Re: Maxwell Colony Farms Wastewater Treatment Lagoon – Environment Act Proposal

MAXWELL COLONY WASTEWATER TREATMENT LAGOON

Re: Maxwell Colony Farms Wastewater Treatment Lagoon – Environment Act Proposal

Proposed Forcemain Location from Lift Station to Proposed Lagoon (preliminary)

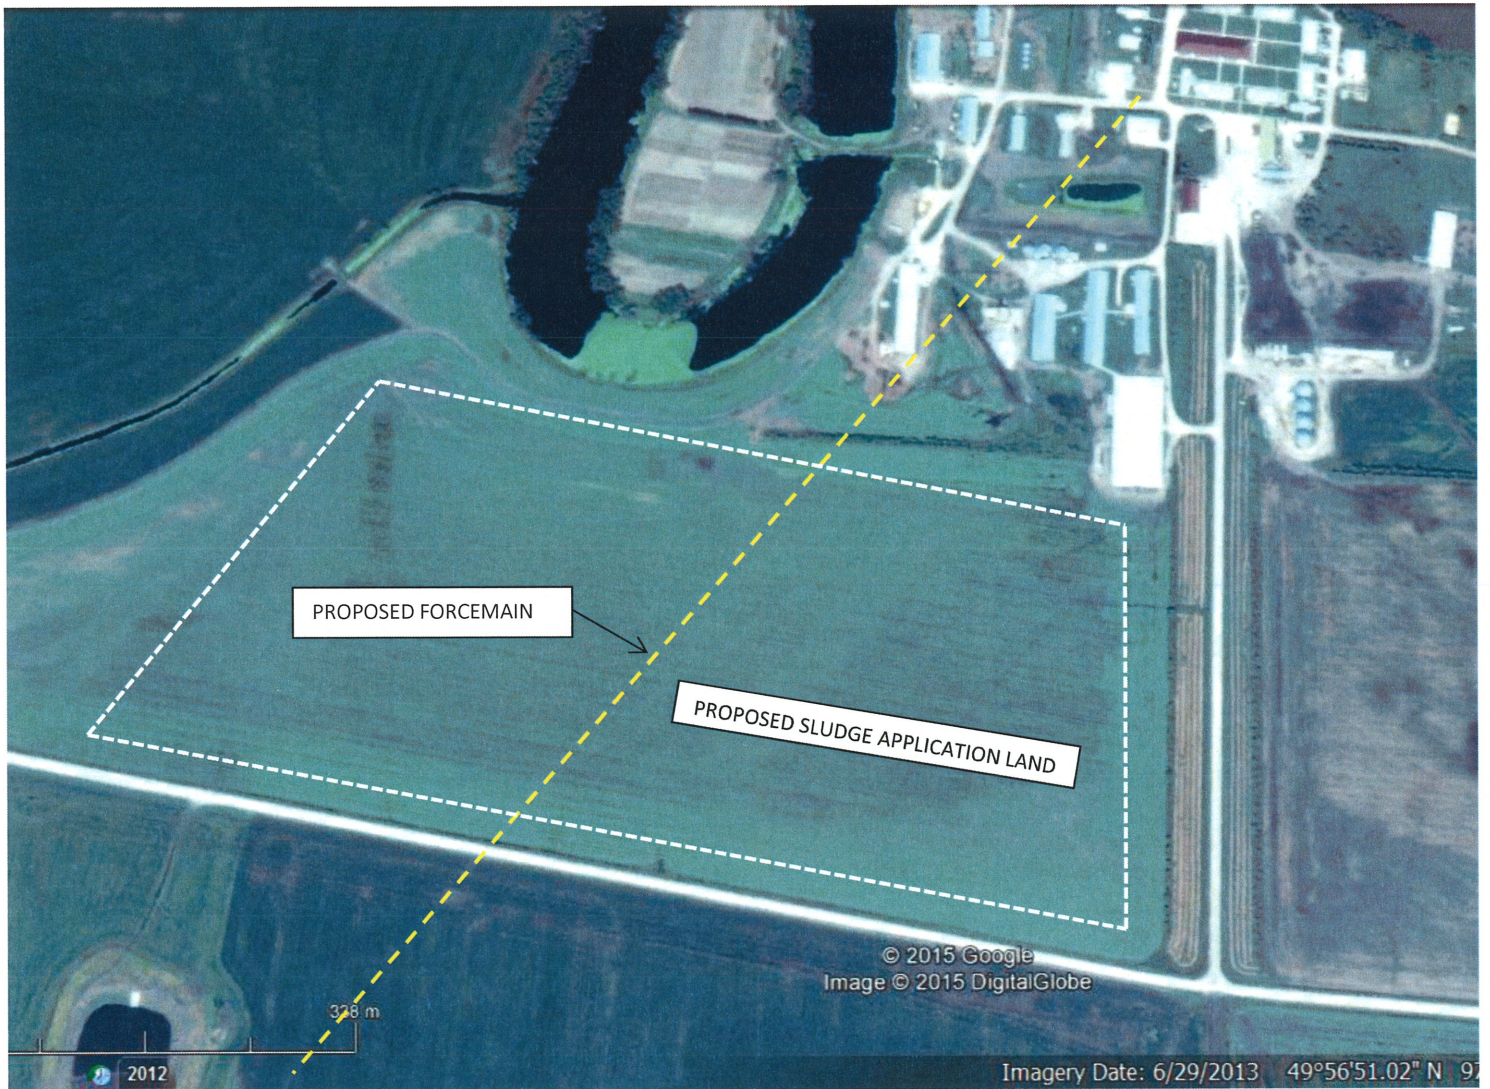
2. Although it is indicated in section 4.7 that the design of the forcemain would be submitted at a later date upon confirmation of the location, please provide general characteristics of the forcemain such as size, route, highway crossing location, etc.

2. The application for approval of the forcemain to the lagoon will be submitted to the Environmental Assessment and Licencing Branch under the Water Works, Sewerage and Sewage Disposal Regulation, MR 33/88R of the Public Health Act at such time as the Licence for the proposed wastewater treatment lagoon is issued. Assuming that a Licence will be issued for the proposed lagoon at the location indicated in the Environment Act Proposal (EAP), the proposed pipeline will be about 900 metres in length, preliminary design at 100 mm diameter (subject to review depending on the assessment and possible modification of the current lift station). The expected alignment will be approximately as shown on the attached photomap of the area. The anticipated coordinates of the Highway crossing are shown on the photomap.

(Highway Crossing at Approximately 49° 56' 40" N, 97° 39' 23" W)

Proposed Decommissioning Sludge Application Land – Approximately 25 Hectares
